SUBJECT: Amendment 4 to the Conventional Explosives Safety Submission for Ordnance and  
Explosives (OE) Removal Action for the Eastern Bypass, of Fort McClellan, Alabama.

**Correction 2**  
**To the Approved Conventional Explosives Safety Submission**  
**Ordnance and Explosives (OE) Removal Action, Eastern Bypass, Fort McClellan, Alabama**  
**30 April 2004**

12.5.1 The attached map, Explosive Safety Submission Eastern Bypass Correction 2, Figure 4, Construction Debris, illustrates grids that require construction support.

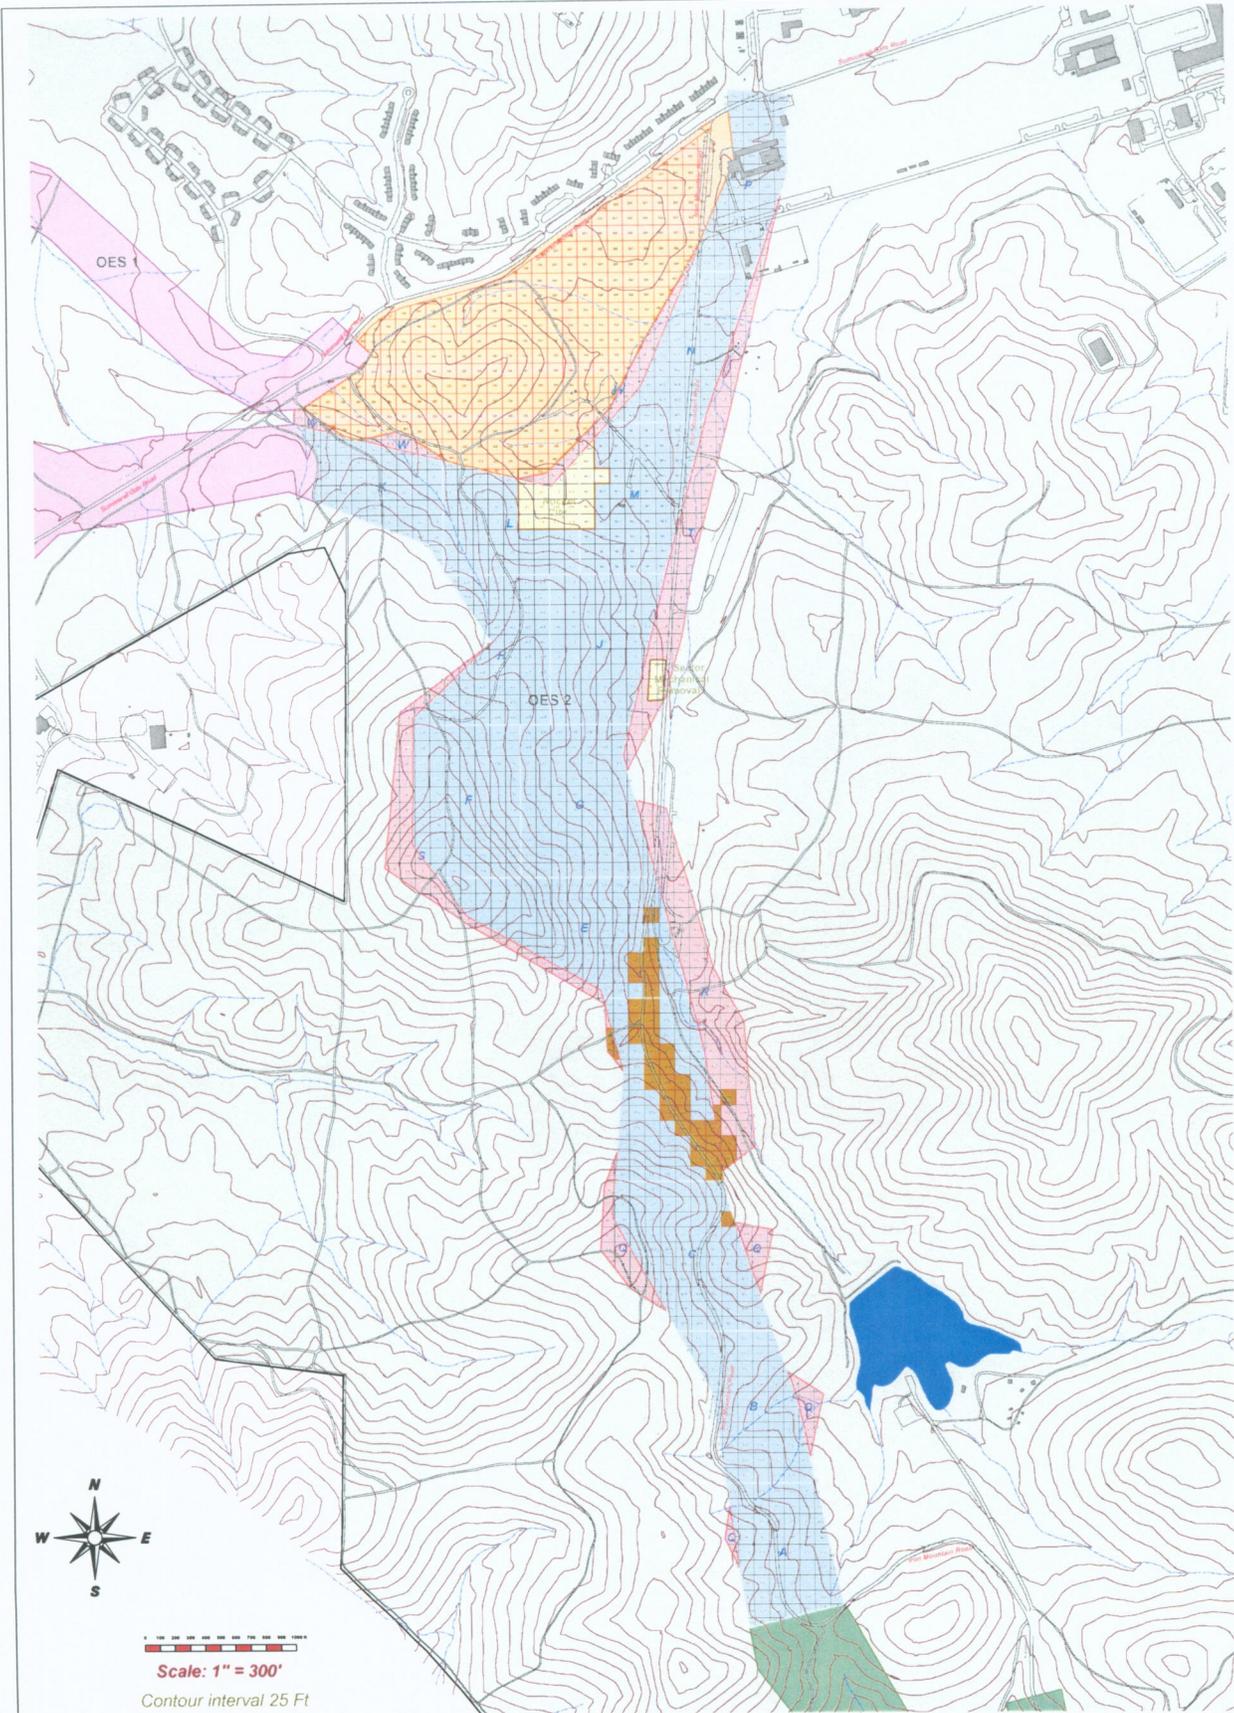
A removal to depth within the OE Area 2 for the grids listed below was not performed because it would require roadway destruction to eliminate the vast quantity of construction debris within designated grids that would interfere with ordnance identification. Furthermore, ALDOT has not provided the Army with a final roadway design for the Eastern Bypass Area. Therefore, the Army will have UXO Technicians present at the time of construction in OE Area 2 to inspect for ordnance after each foot of construction debris removed. This process will continue until the bottom of the debris pile is reached. Once virgin soil (undisturbed) is encountered, the Army will perform a subsurface removal to depth. The construction debris grids are identified in the following table:

C67	D22	D35	D54	D69	E12	R01	R13
D07	D23	D41	D55	D75	E13	R02	R18
D08	D28	D42	D61	D76	E22	R03	S02
D14	D29	D47	D62	D82	E23	R05	S03
D15	D30	D48	D66	D83	E35	R06	S04
D16	D34	D49	D68	E05	E63	R09	S05

Table 5 Construction Debris Grids

10.1 The U.S. Army has agreed to provide construction support for the grids identified in Table 5 above once intrusive construction operations begin. Access to the construction site will be granted only to those individuals that have viewed the UXO safety digital video.
